Consultant Advice Notice

Thornbury House – 716 High Street, Thornbury VIC 3071

Addendum to Acoustic Town Planning Report

PLAN LEVEL 2

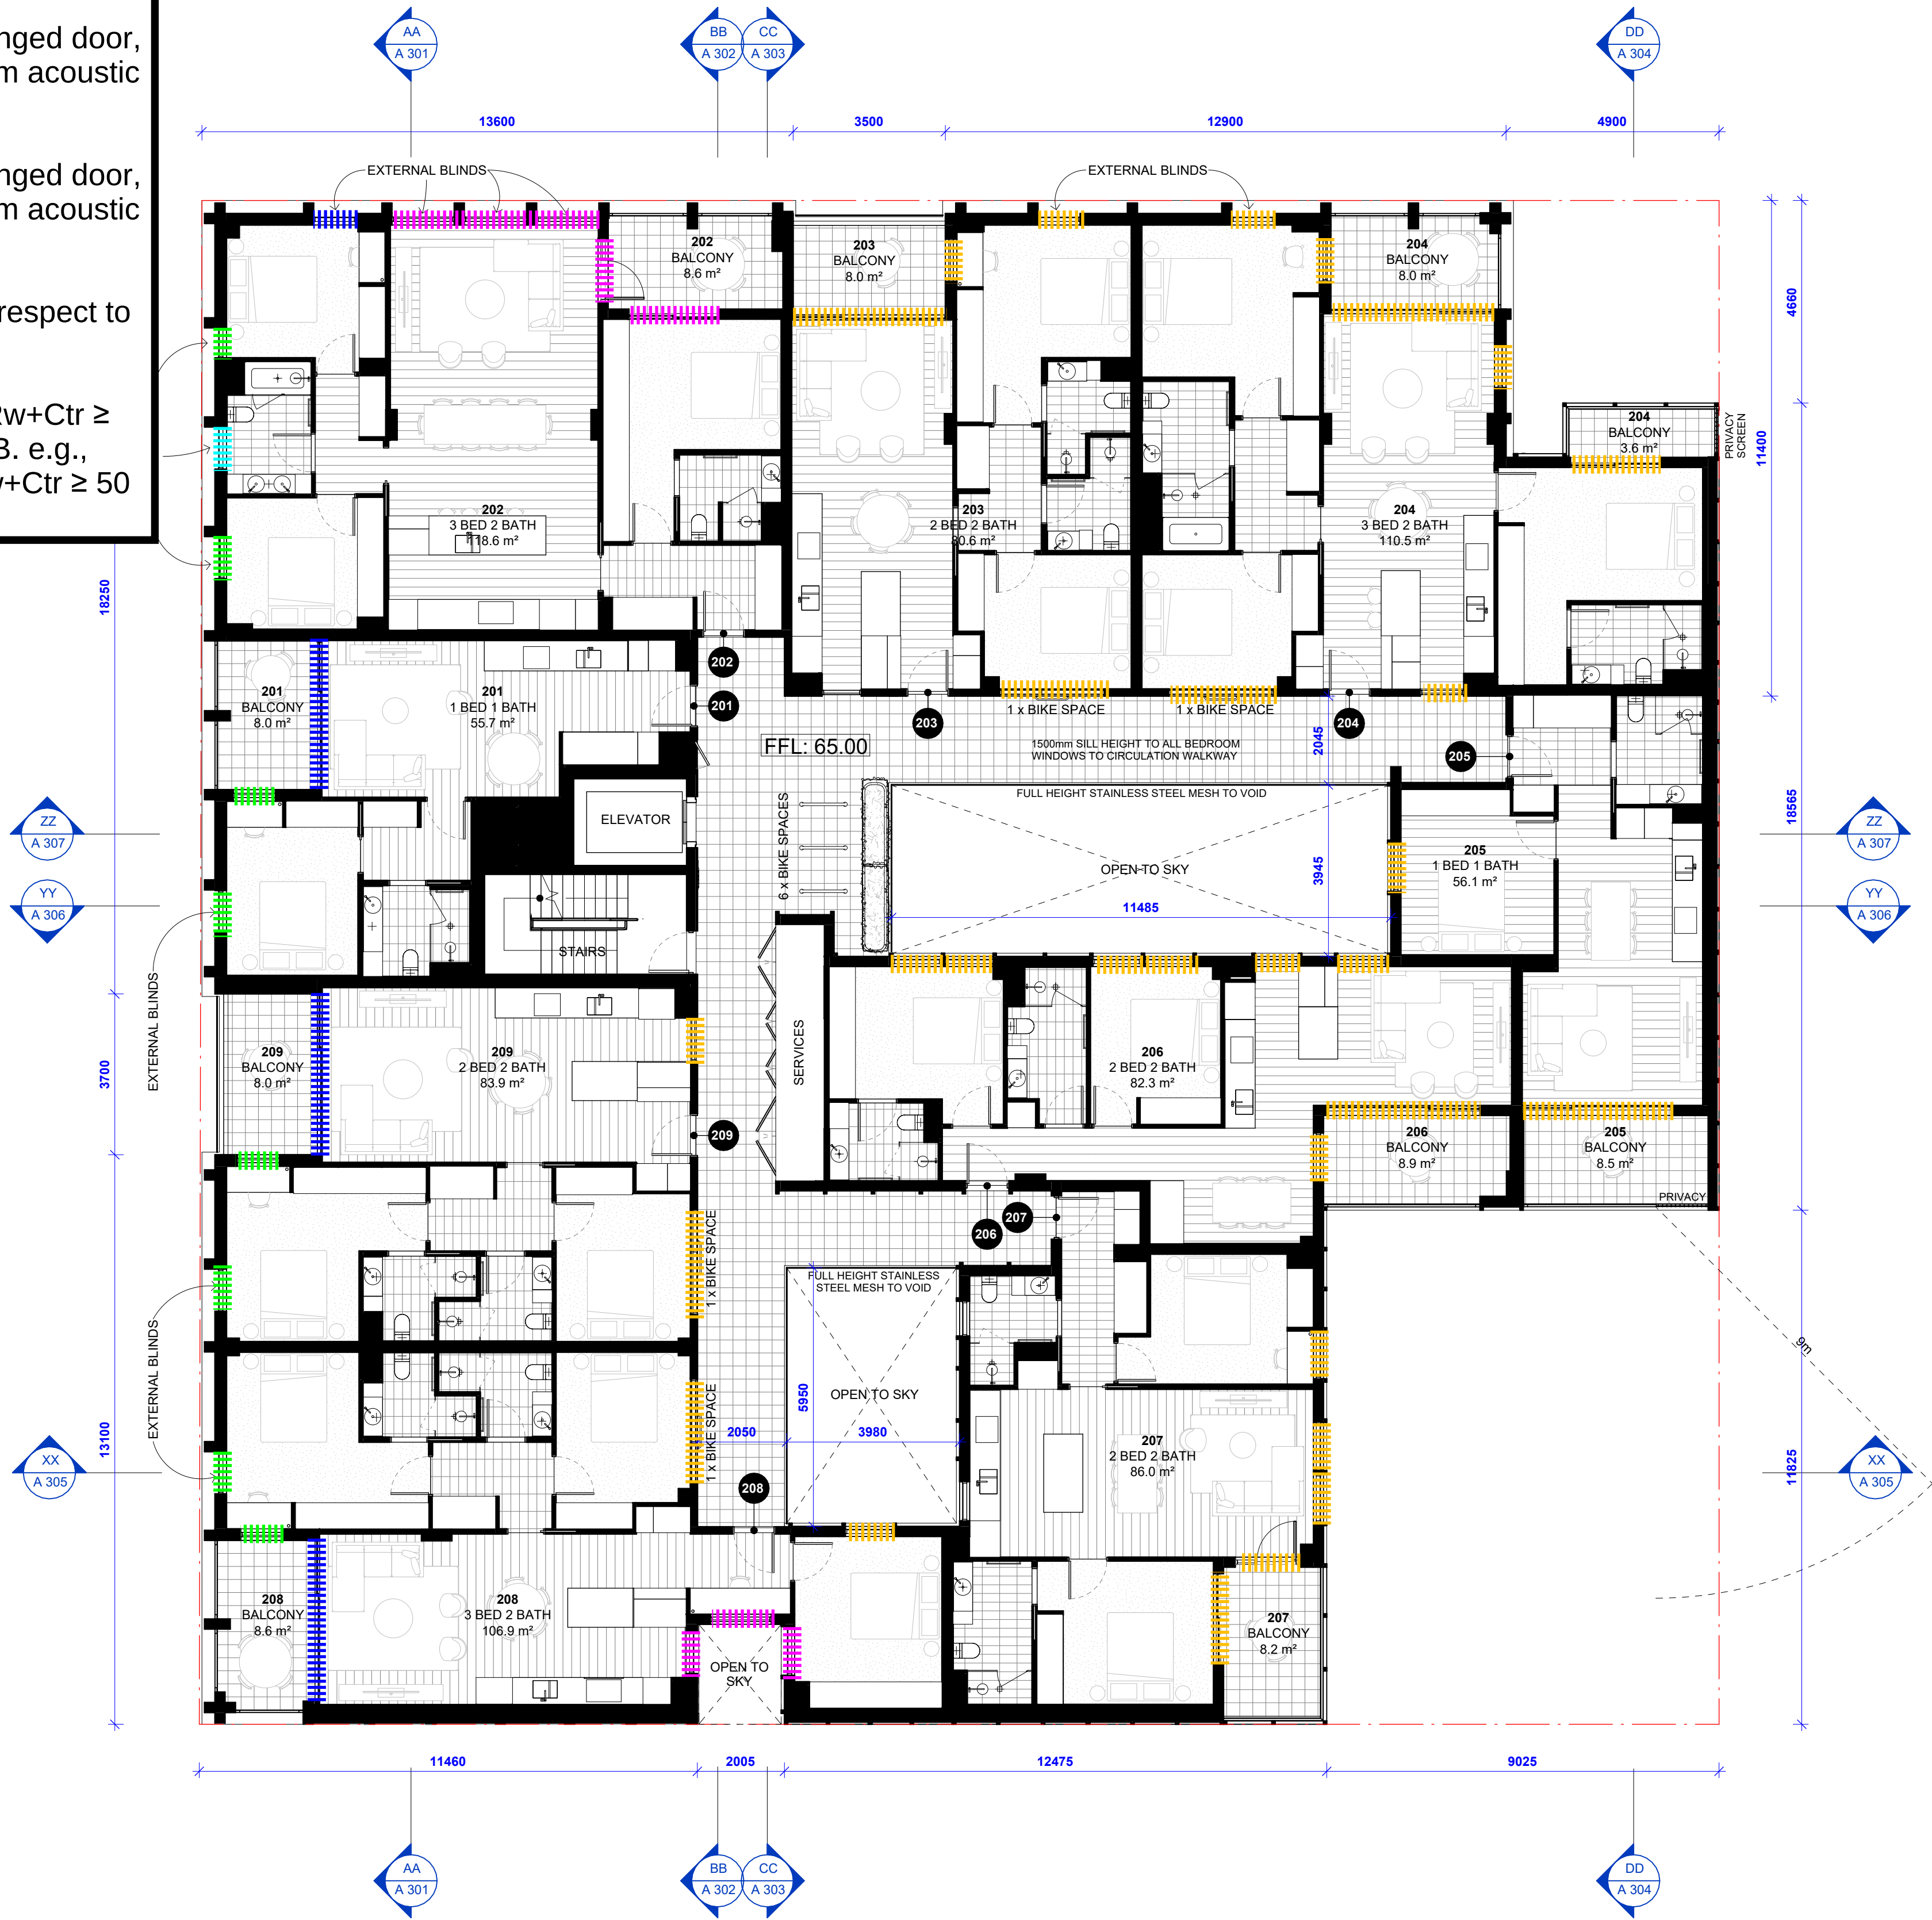
Fixed/awning glazing, sliding door or hinged door, including any frames and seals to have a minimum acoustic rating of Rw 40.

Fixed/awning glazing, sliding door or hinged door, including any frames and seals to have a minimum acoustic rating of Rw 38.

Fixed/awning glazing, sliding door or hinged door, including any frames and seals to have a minimum acoustic rating of Rw 36.

Fixed/awning glazing, sliding door or hinged door, including any frames and seals to have a minimum acoustic rating of Rw 32.

Opaque sections of the façade shall be rated to $Rw+Ctr \geq$ the glazing performance requirement (Rw) + 10dB. e.g., opaque section of the facade shall be rated to $Rw+Ctr \geq 50$ proximate to Rw 40 rated glazing.

PLAN LEVEL 4

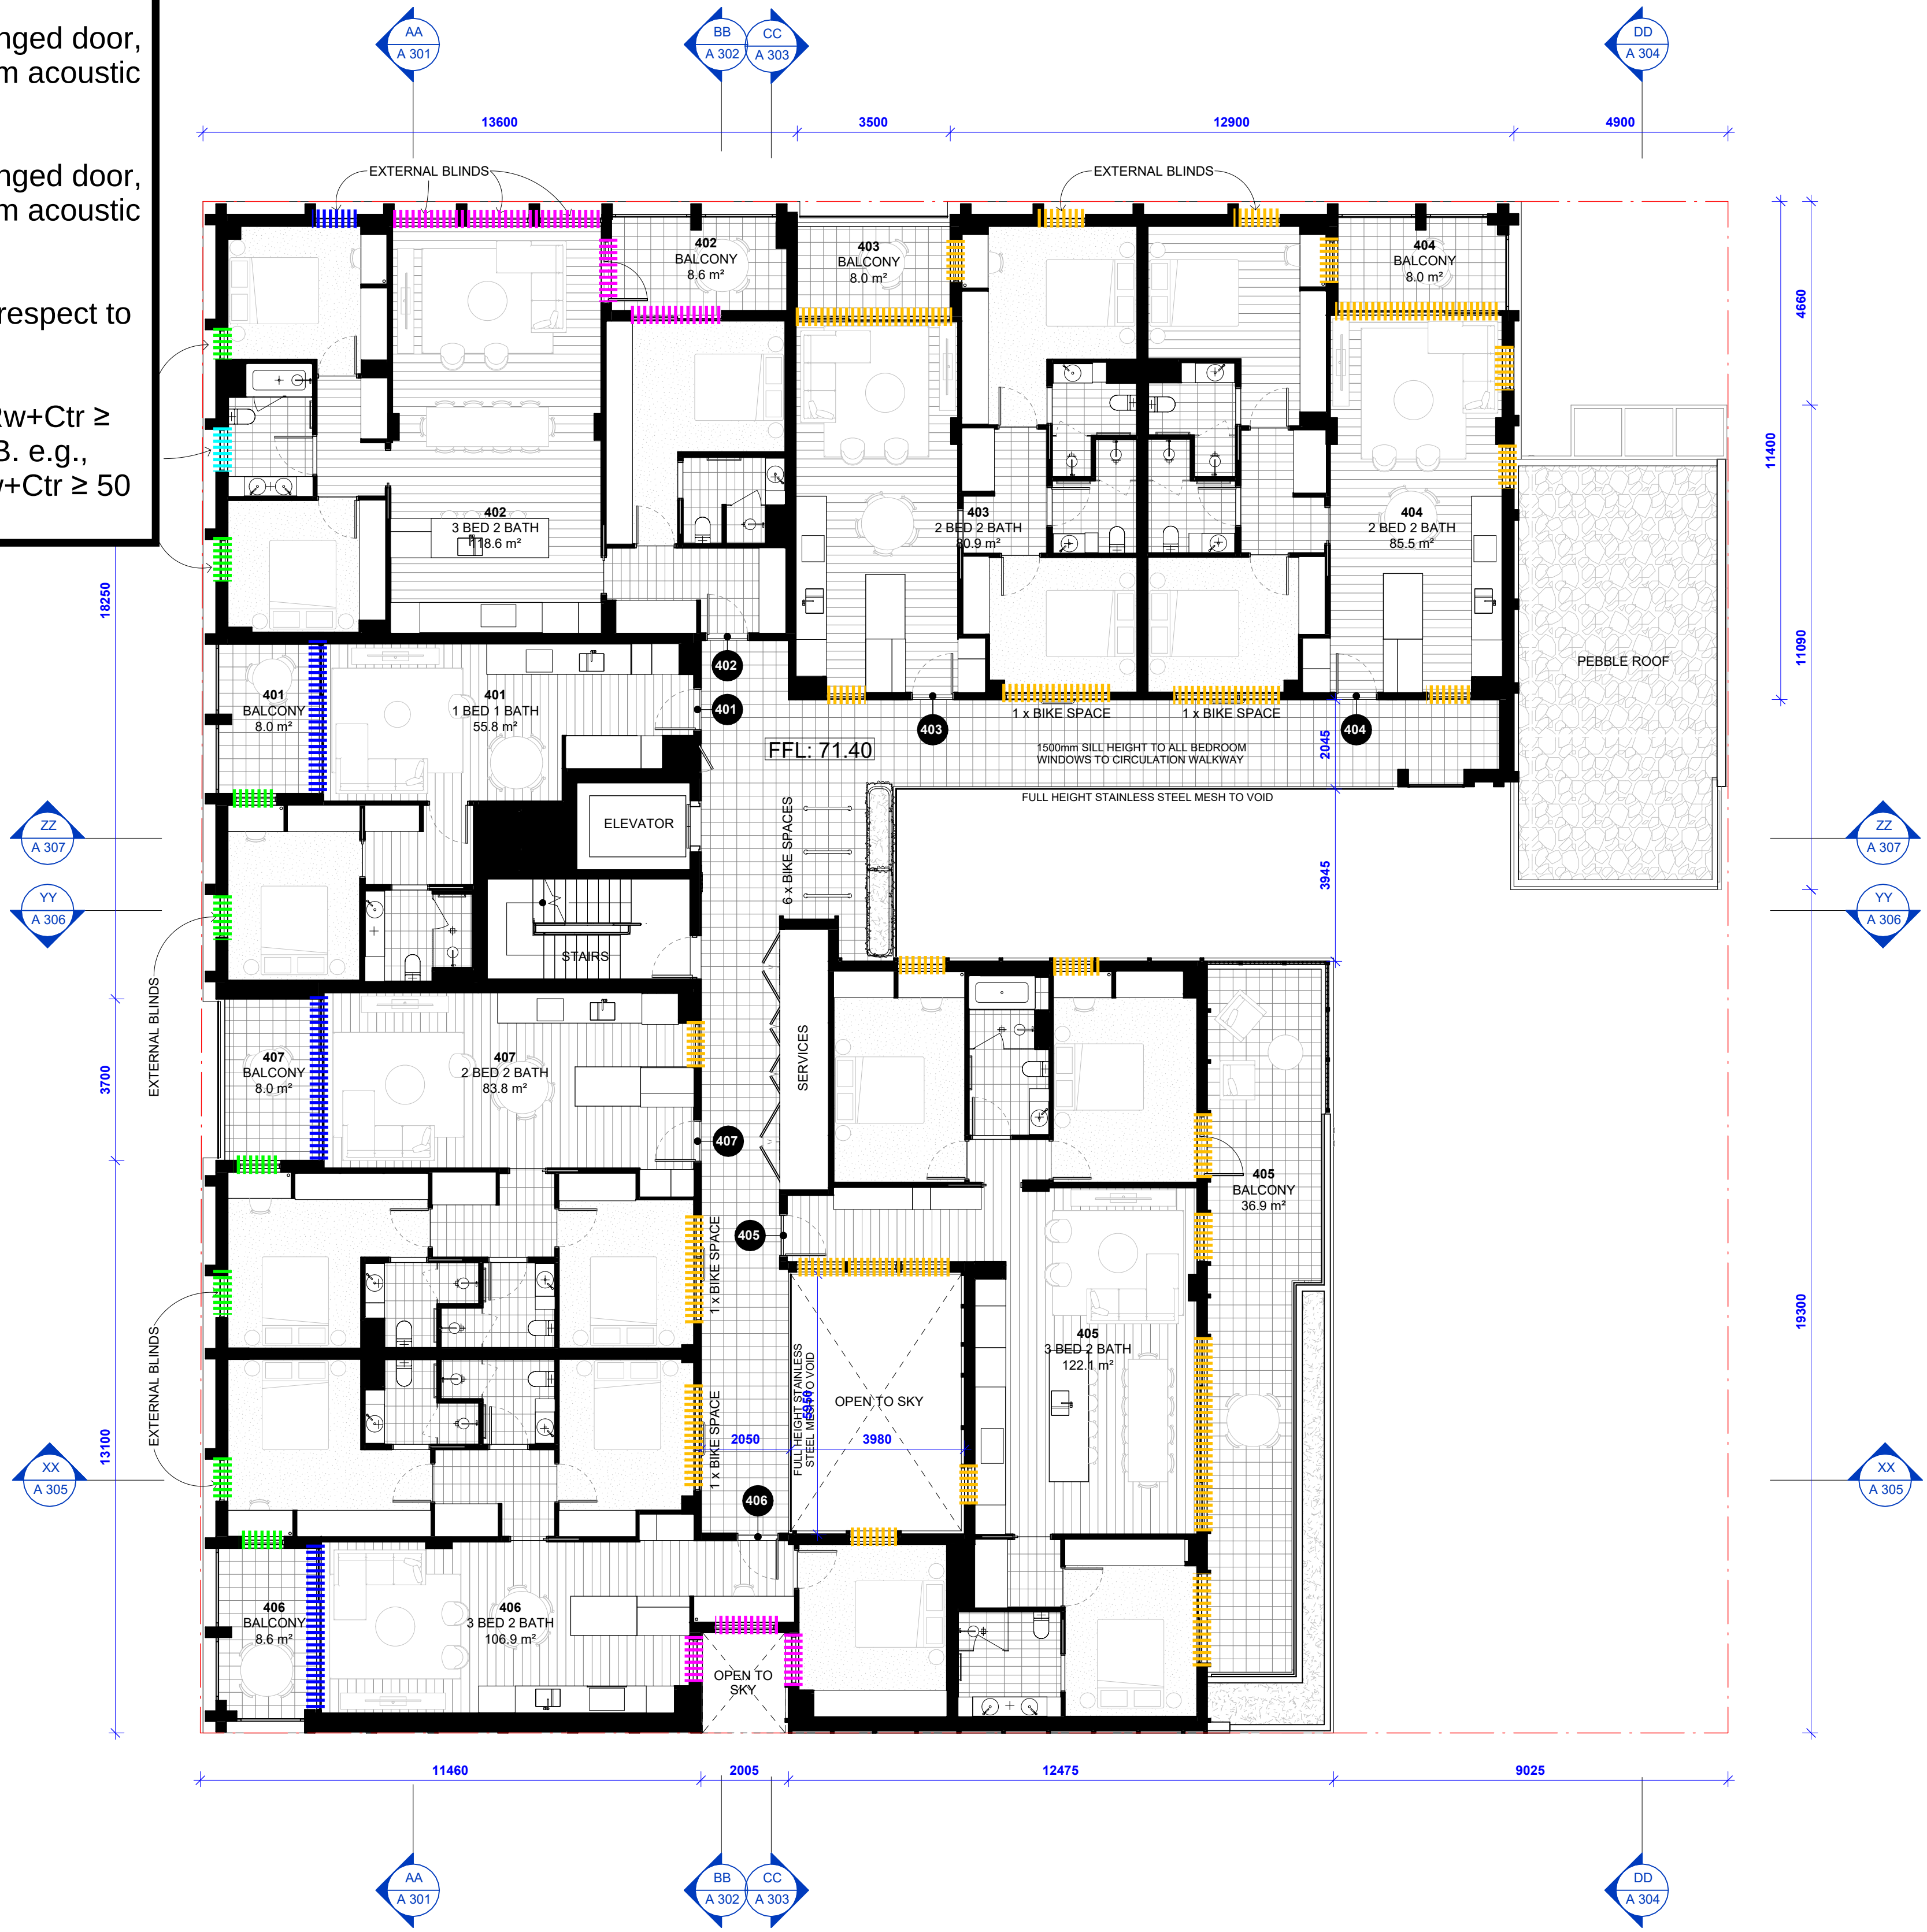
Fixed/awning glazing, sliding door or hinged door, including any frames and seals to have a minimum acoustic rating of Rw 40.

Fixed/awning glazing, sliding door or hinged door, including any frames and seals to have a minimum acoustic rating of Rw 38.

Fixed/awning glazing, sliding door or hinged door, including any frames and seals to have a minimum acoustic rating of Rw 36.

Fixed/awning glazing, sliding door or hinged door, including any frames and seals to have a minimum acoustic rating of Rw 32.

Opaque sections of the façade shall be rated to $Rw+Ctr \geq$ the glazing performance requirement (Rw) + 10dB. e.g., opaque section of the facade shall be rated to $Rw+Ctr \geq 50$ proximate to Rw 40 rated glazing.
